ROOSEVELT CAMPOBELLO INTERNATIONAL PARK
VISITOR CENTER REDEVELOPMENT PLAN

RFP 2019-001

ADDENDUM NO. 2

EAST ELEVATION
PROPOSED ADDITION SCALE $\frac{1}{8}'' = 1'-0''$
NOV. 2002 GWM.

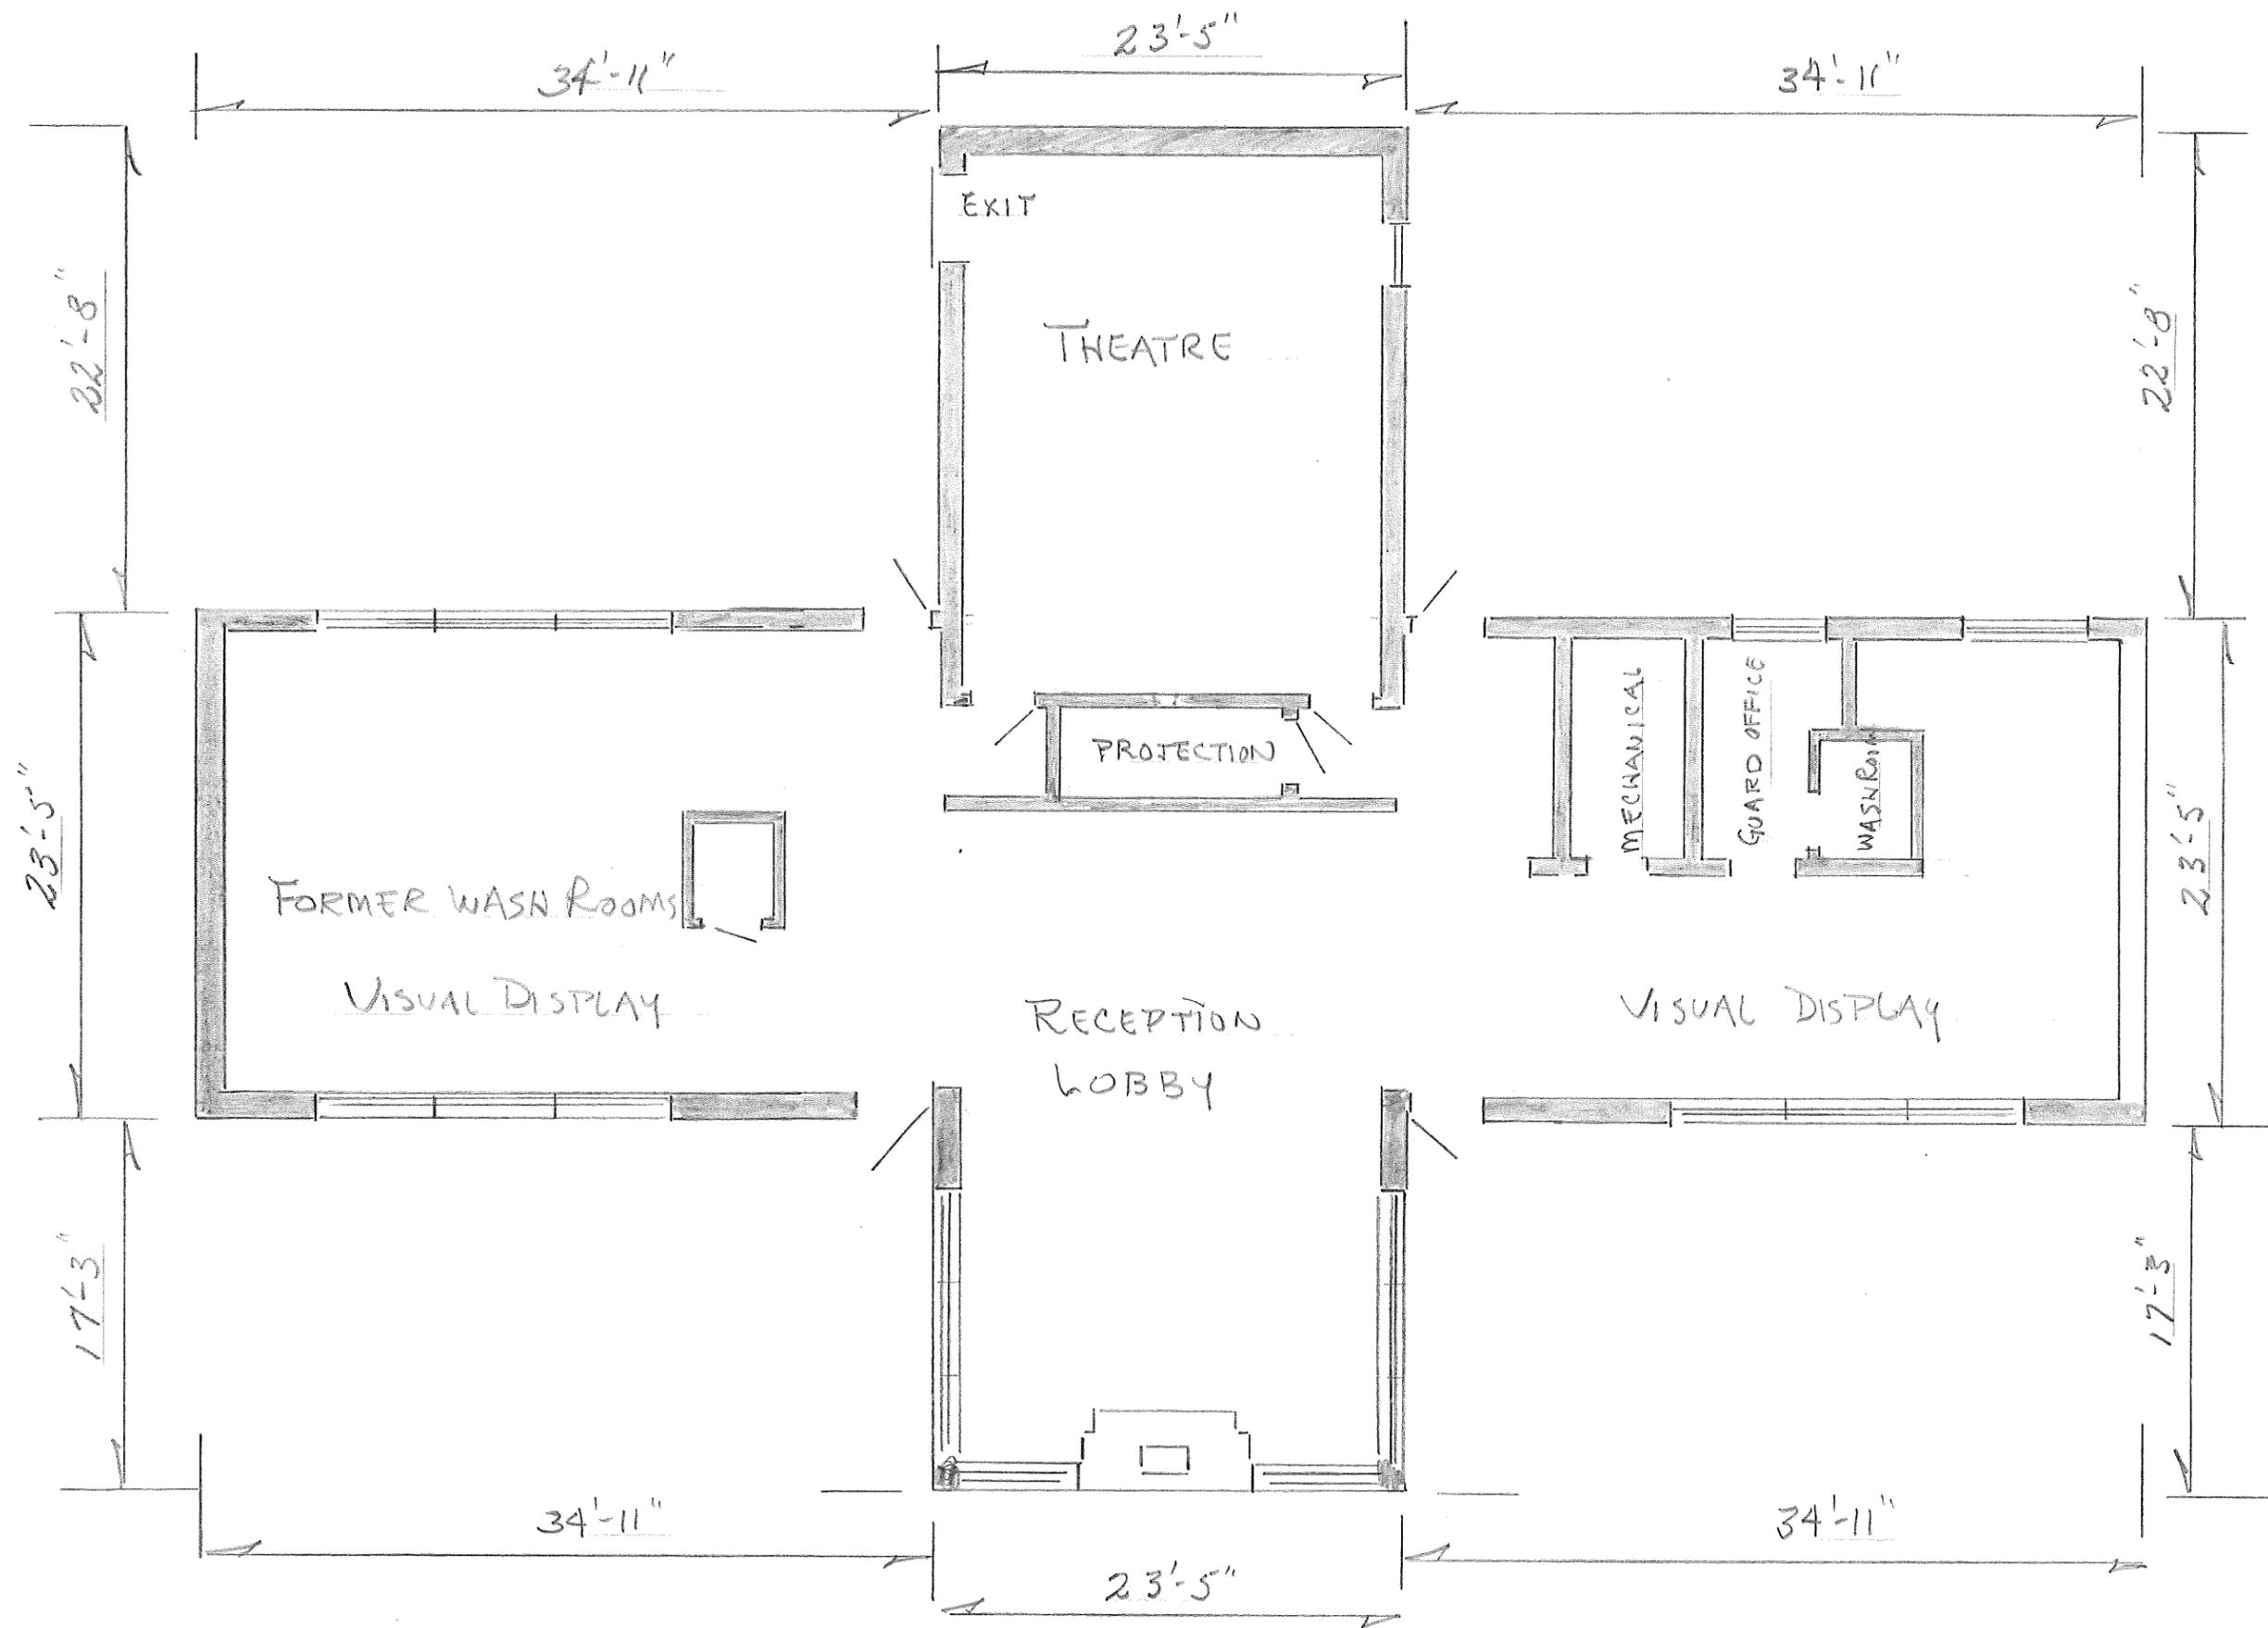
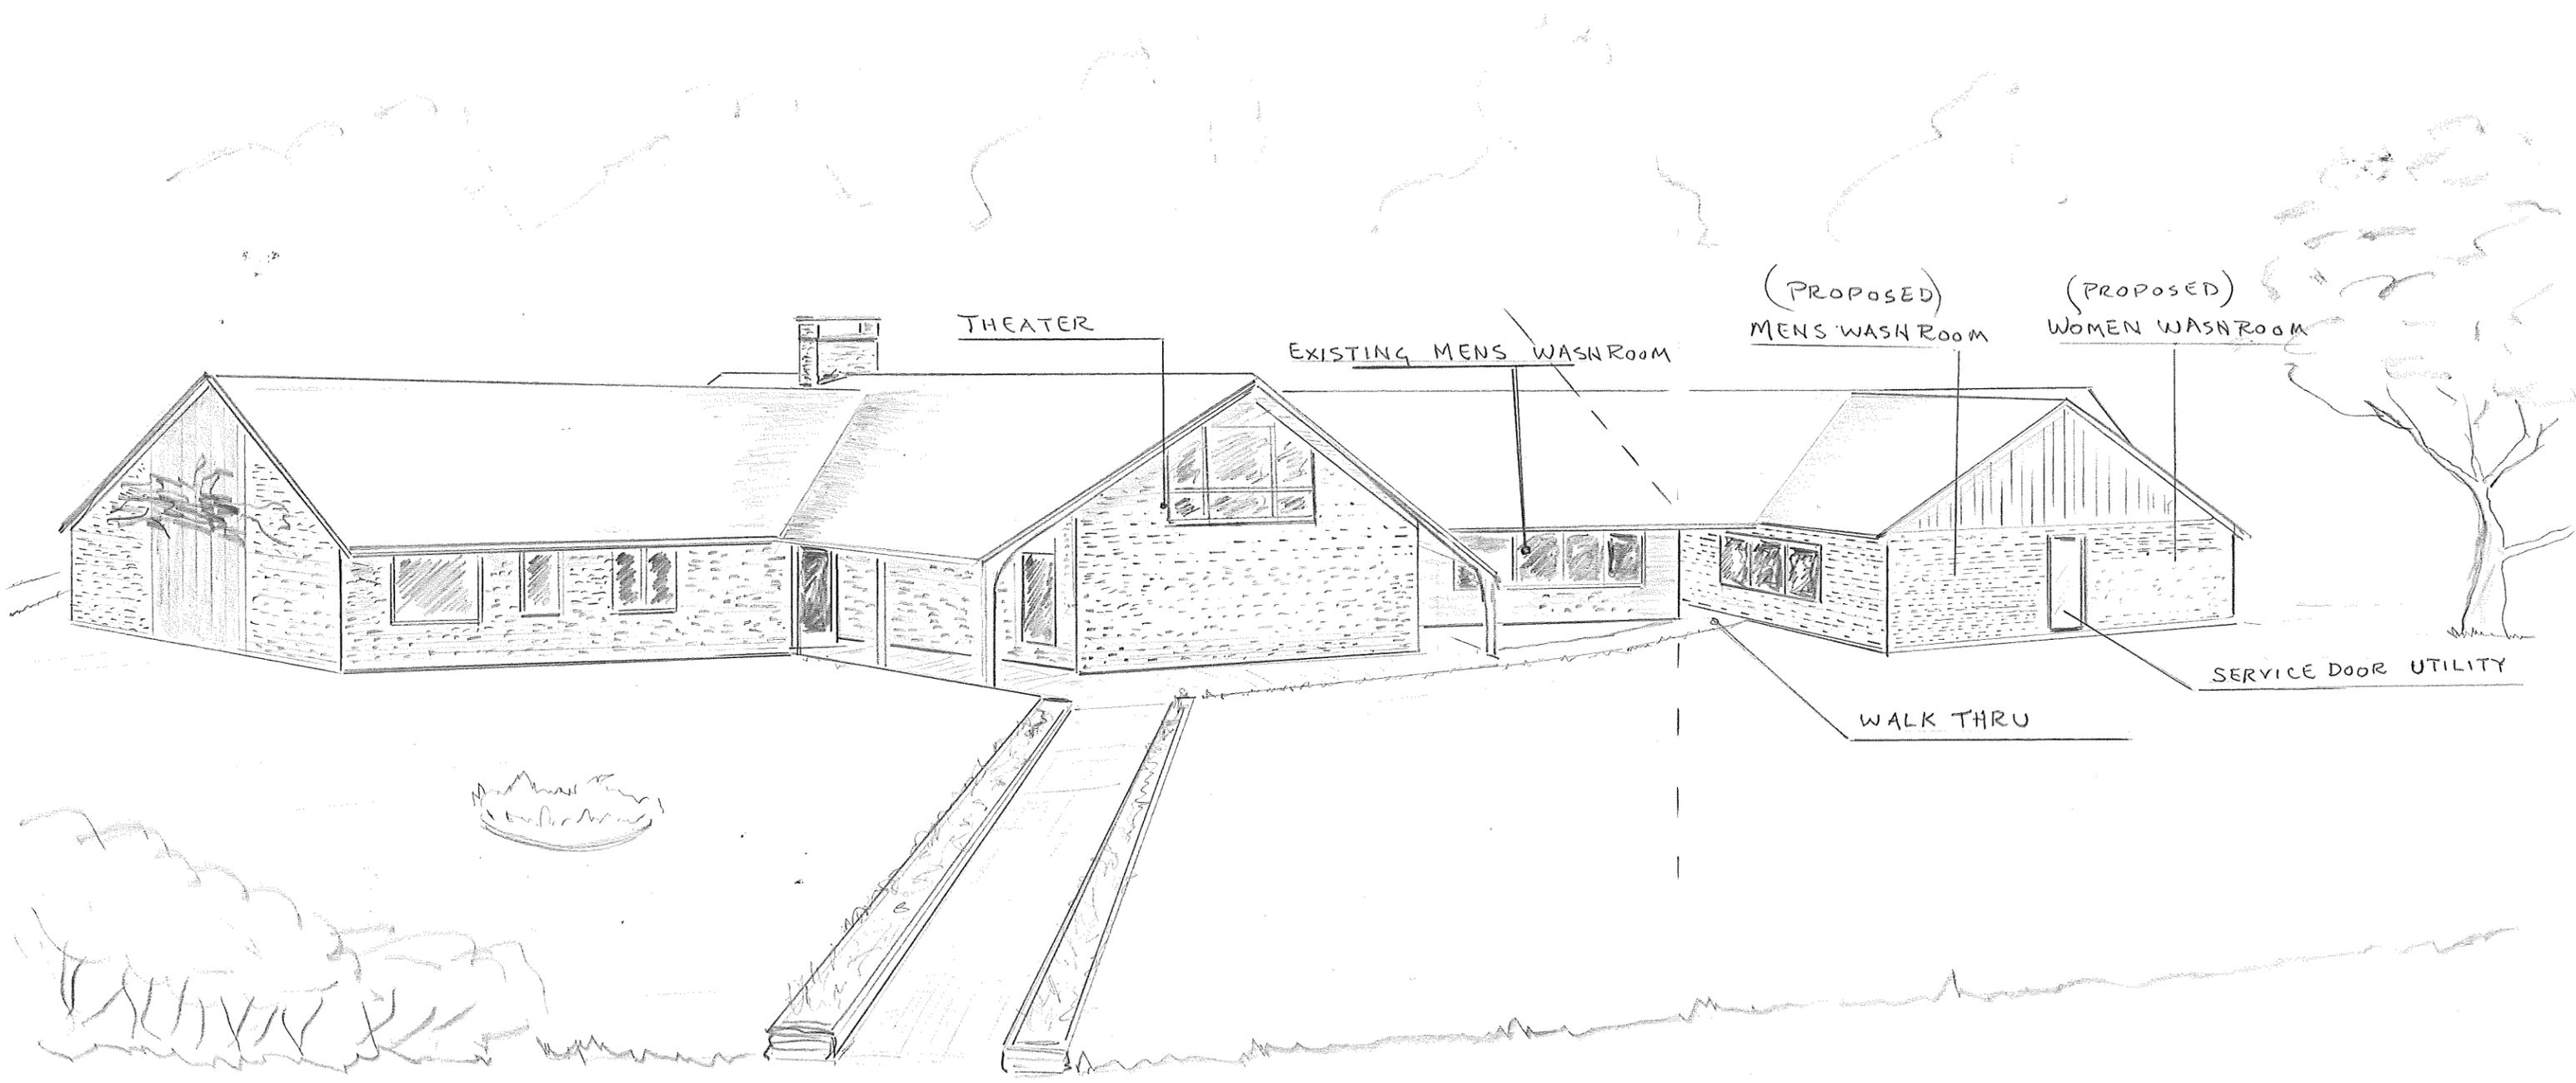
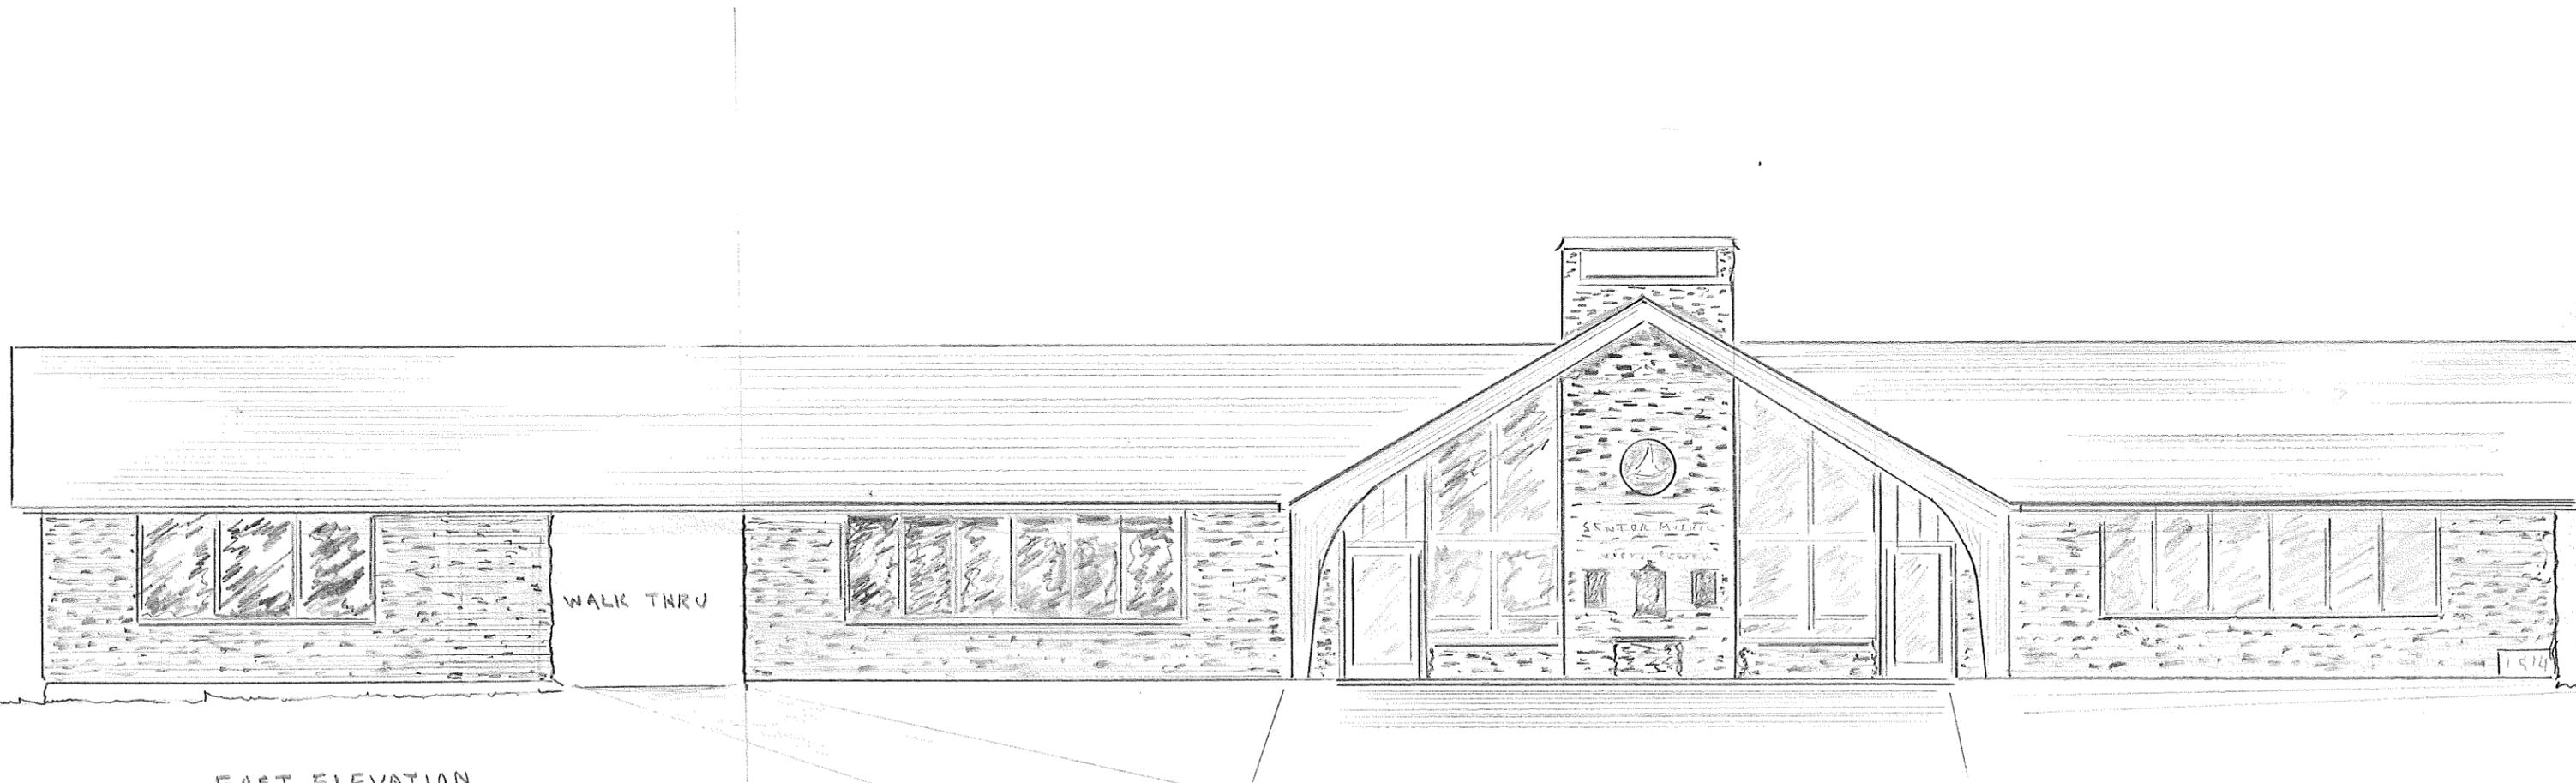
2. *There is mention of a redevelopment project that occurred in 2004, do you have the plans of that renovation available?* **The 2004 renovations saw the elimination of washroom facilities from the south wing of the original footprint. A standalone washroom facility was constructed on the southern end of the building and connected to the original structure with a brick paved breeze way and trussed roof system. The Renovation Plan is attached to this Addendum #2**
